# UNITED STATES PATENT AND TRADEMARK OFFICE

APPLICATION NO.	FILING DATE	FIRST NAMED INVENTOR	ATTORNEY DOCKET NO.	CONFIRMATION NO.
10/772,657	02/05/2004	Brian C. Adamski		5580

**Office Action Summary**

## DETAILED ACTION

FIG. 14

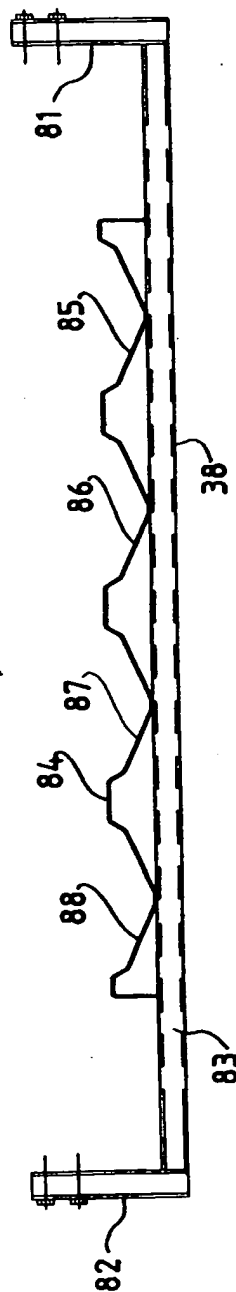
See the attached marked up drawing figures 14-16, 20, and 24 of Wierschke depicting the claimed features.

RE: CLAIMS 14 & 15

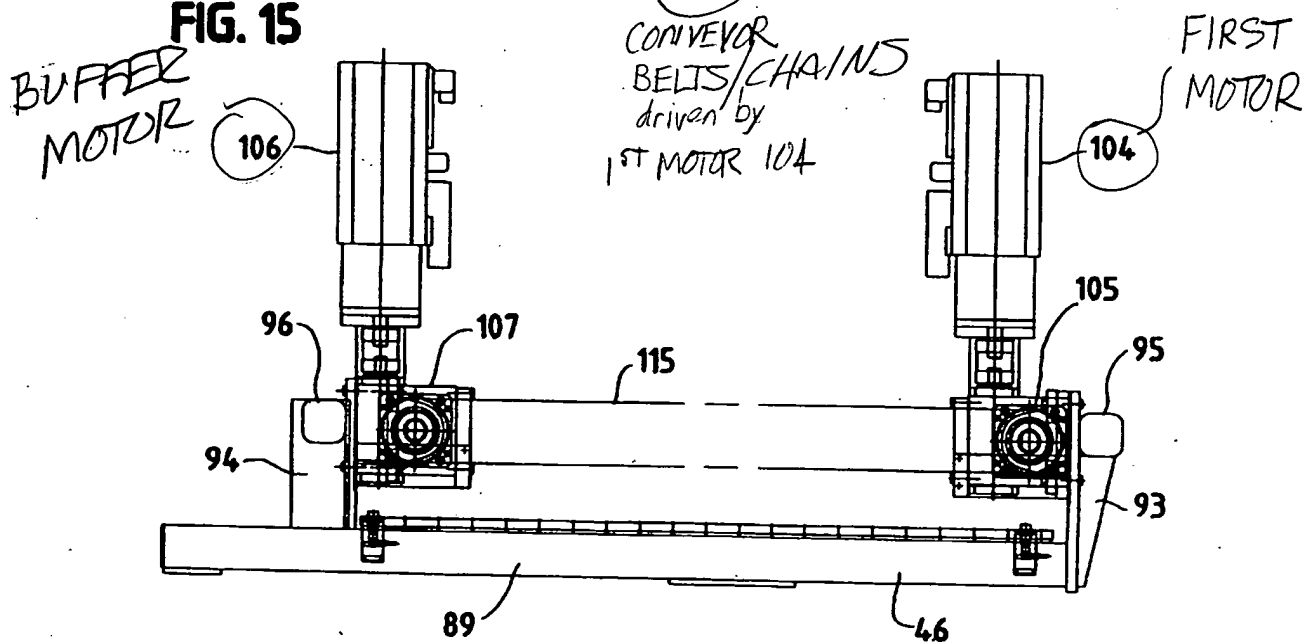
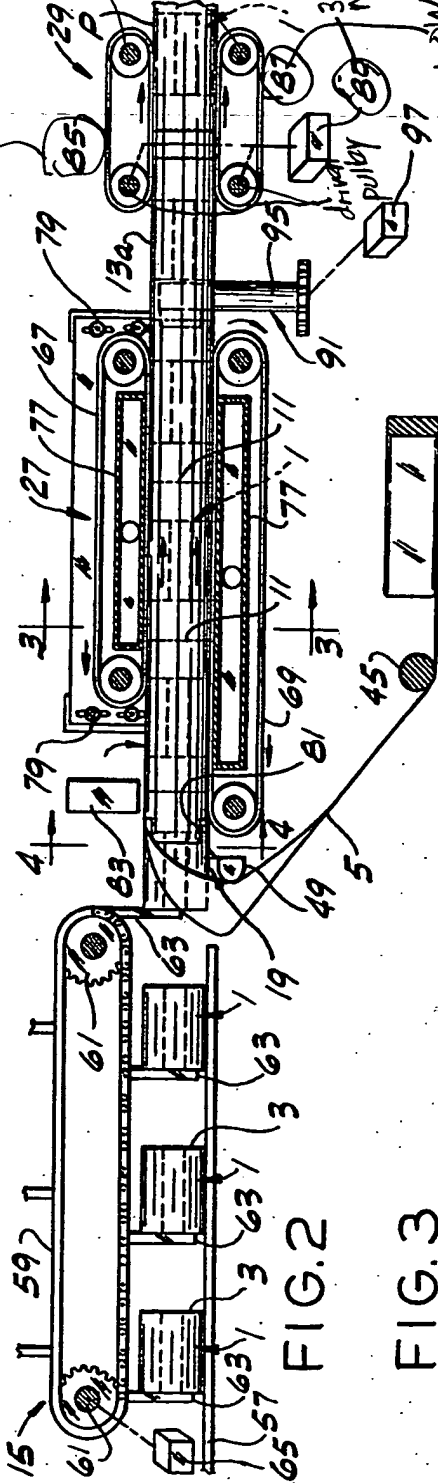
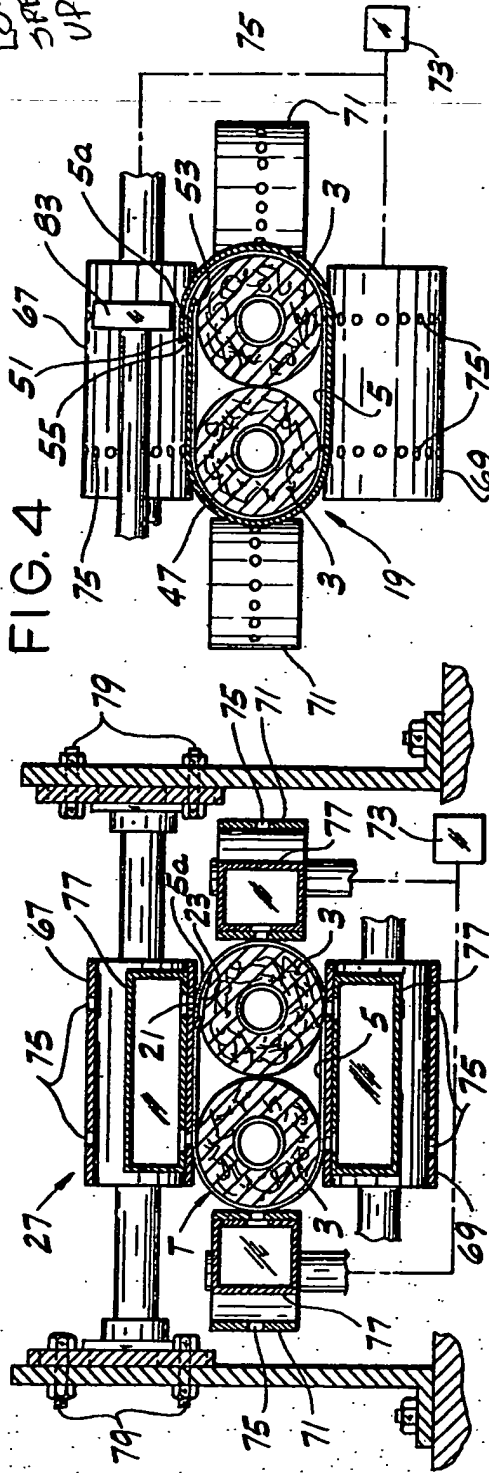
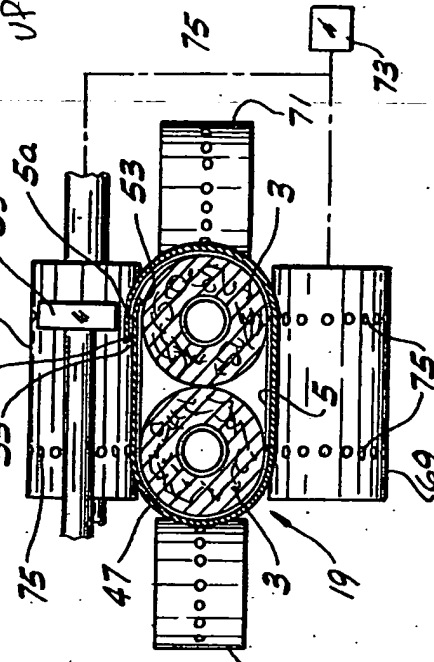
7. Claims 14 and 15 are rejected under 35 U.S.C. 103(a) as being unpatentable over Wierschke (as cited above) in view of James (US Pat. No. 4,430,844).

Wierschke teaches the claimed invention as outlined above, but fails to teach upper and lower speed up belts at the exit portion of his conveyor. Wierschke's device is only directed at the features within his drawing limits and would inherently include an exit conveyor of some sort at his exit end. James teaches a wrapping apparatus which shows a conveyor at the exit end having the claimed features as shown on the attached marked up drawing figure 2 of James. It would have been obvious to one of ordinary skill in the art at the time the invention was made to
